Abravanel Hall Masterplan

Executive Summary

Abravanel Hall Master Plan Executive Summary

ABRAVANEL HALL
MASTER PLAN AND PROGRAMING PACKAGE
21 JANUARY 2015

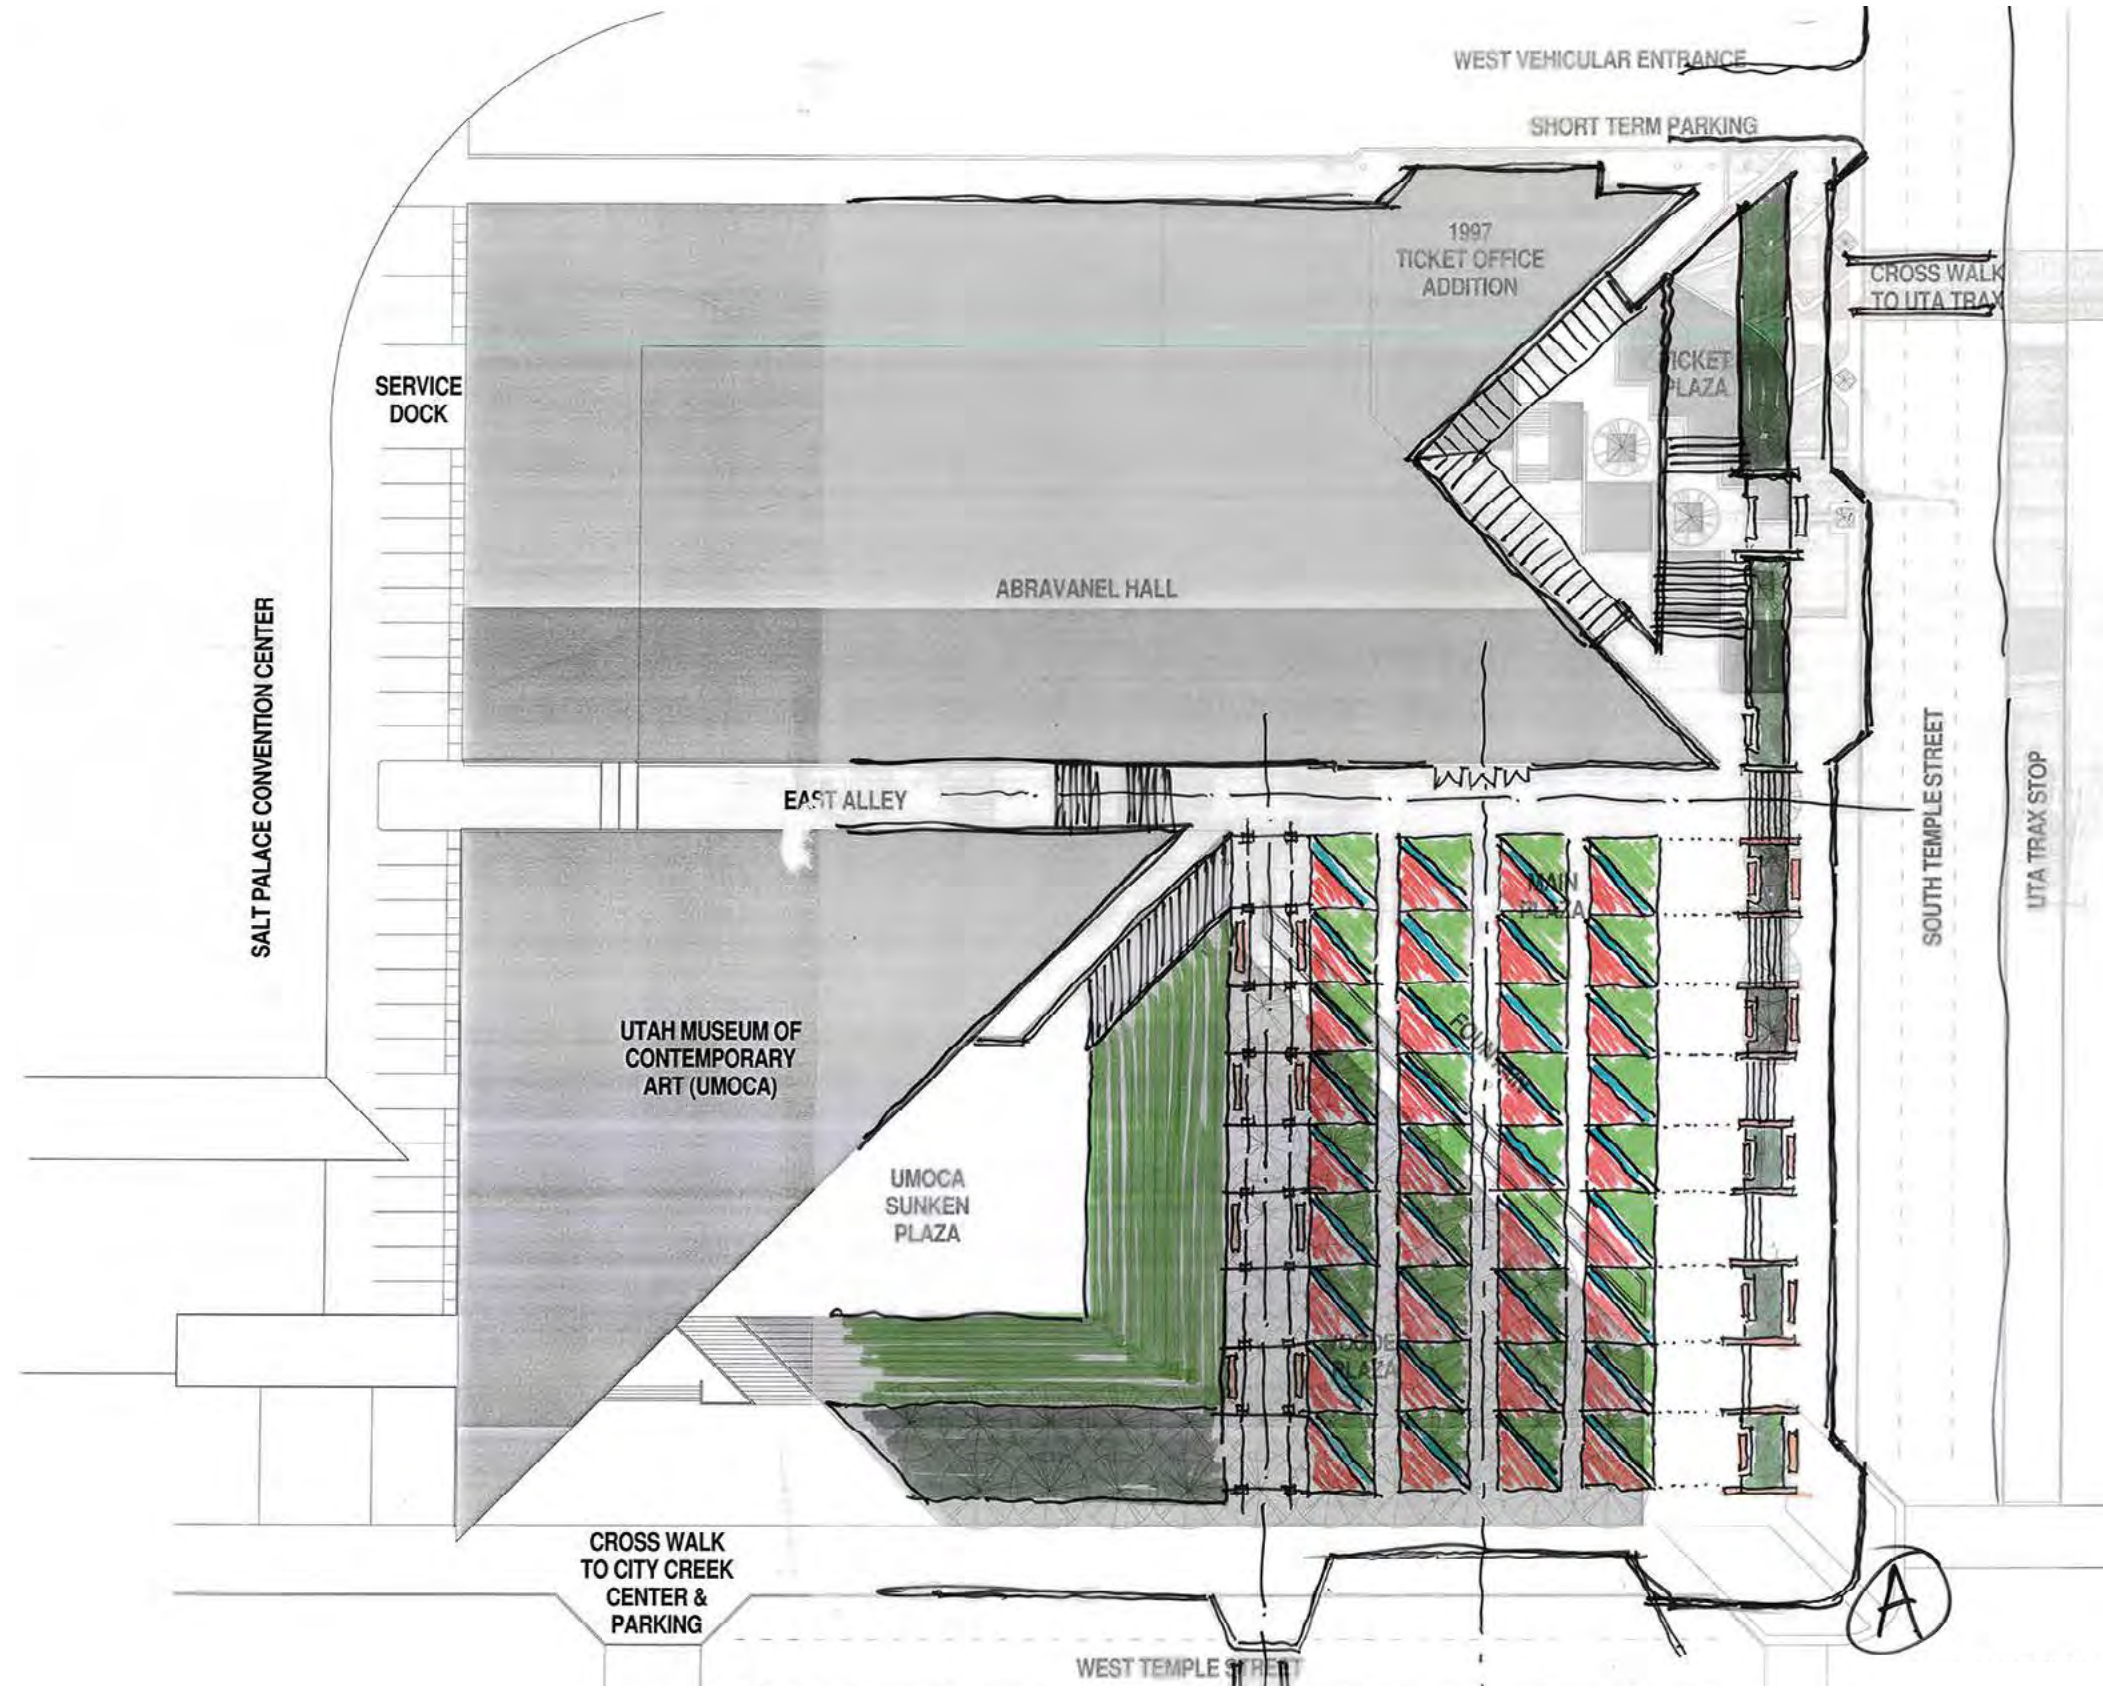
Review comments included:

- Does not have adequate landscaping.
- Circulation is limited.
- Needs further development.

After review, the group chose “Scheme C” as the concept plan to be developed further, for Phase 1 Design - Part A (Immediate Needs).

KEYED NOTES - UPDATED 2/19/14

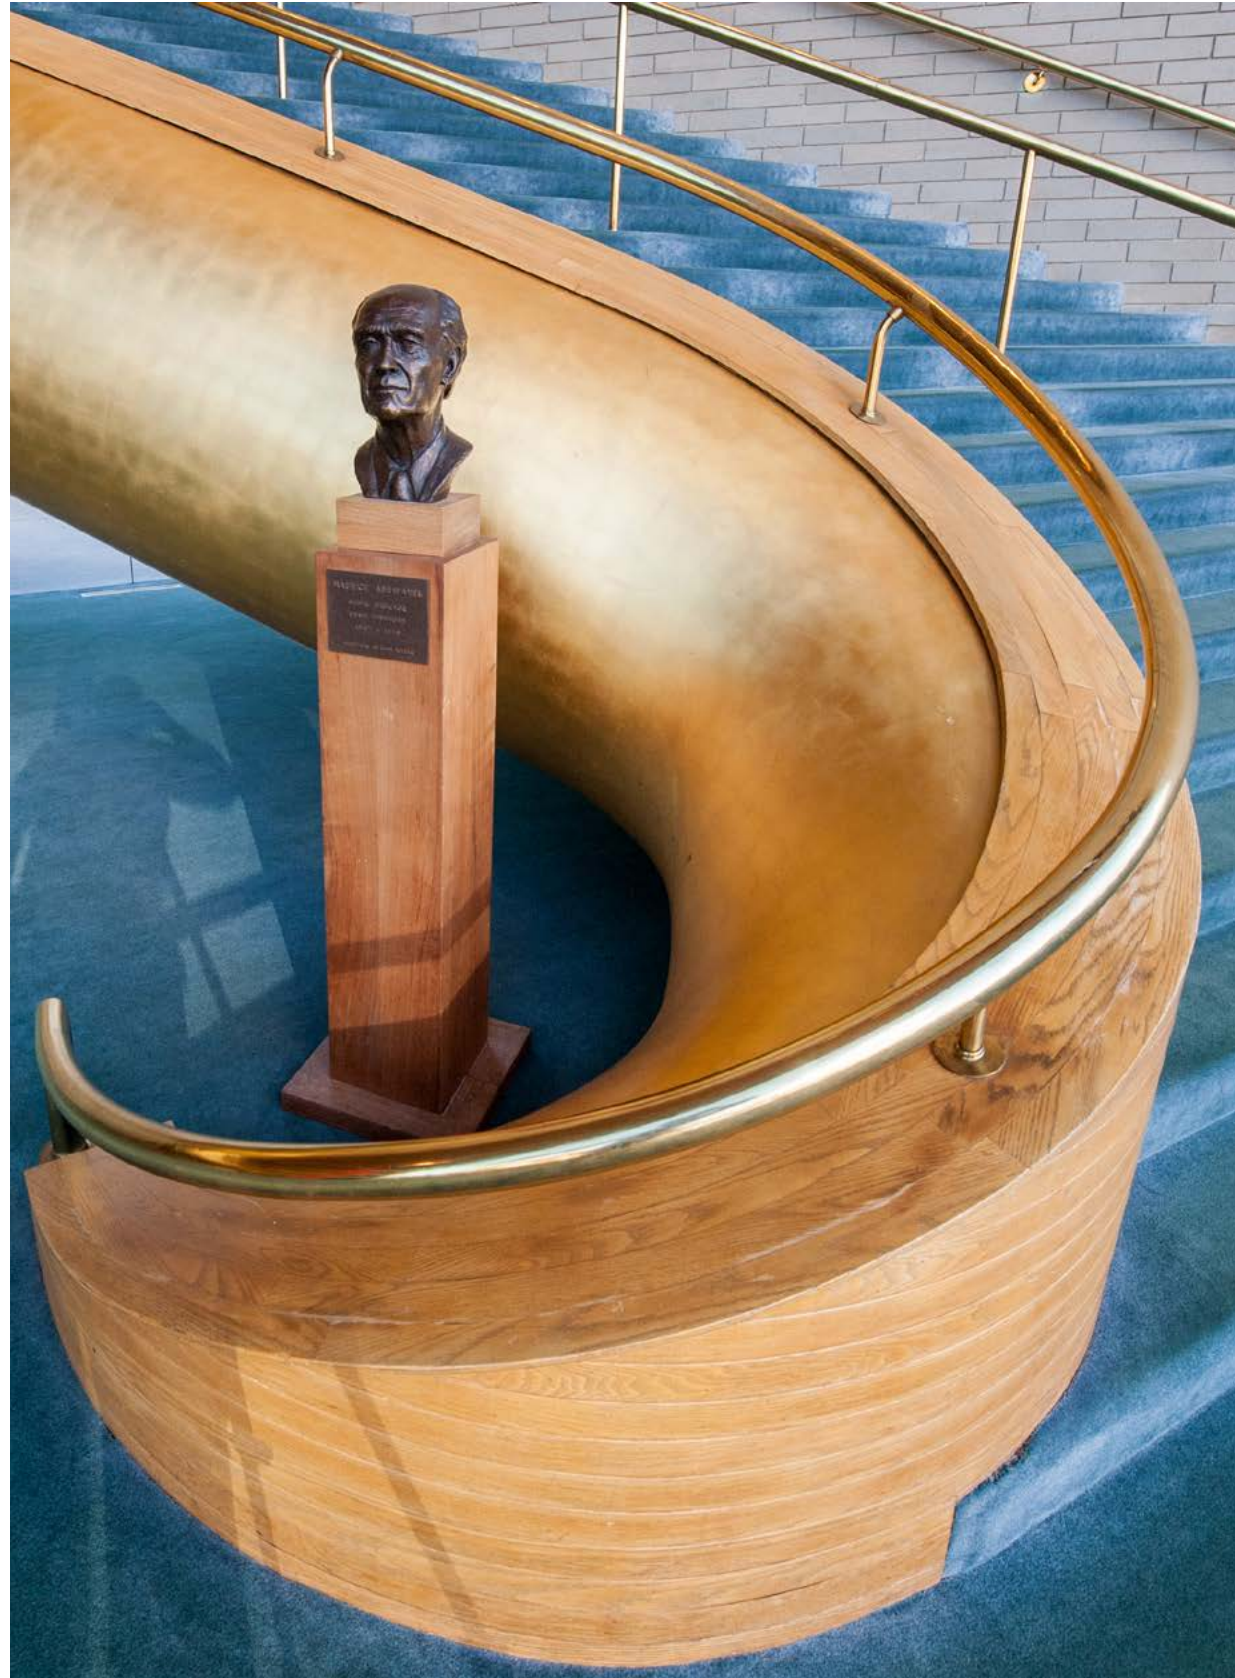
1. A better location for a floor infill and for concessions may be on the second tier lobby. Keep the first tier lobby for the VIP's and not have to worry about "separating" VIP's from concessions patrons.
2. Still under consideration, especially for VIP area.
3. Noted.
4. Space could become shared area for both the first tier room and for what is decided for the first tier level of the new north building. Access for this area could be provided from both the first tier room, and from the grand staircase.
5. Roof area could also be used for needed space for back of house offices, symphony program, or other functions.
6. This was reviewed by the group and did not seem to be a viable solution for concessions. The second tier option for concessions was preferred.
7. Noted.
8. Needs further discussion.
